Freetown Bandstand

Town of Freetown ADA Transition Plan

June 2023

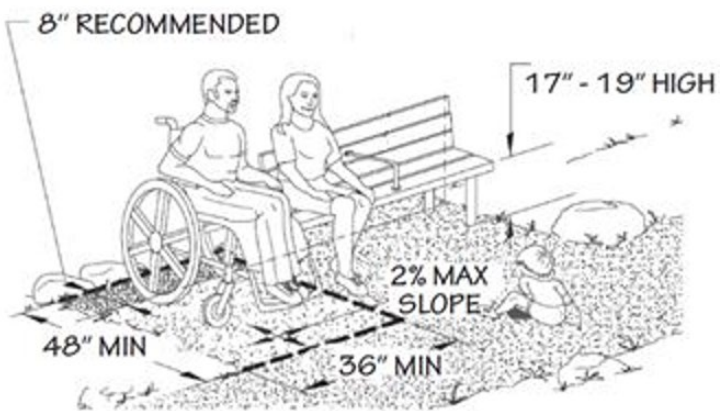
- Recommend providing a 36" by 48" min. stable, firm and slip-resistant area alongside at least one bench in each distinct area where benches are provided so that a person using a wheelchair or other mobility device is able to sit alongside someone seated on the bench with their shoulders aligned. See the following illustration for best practice recommendations for benches:
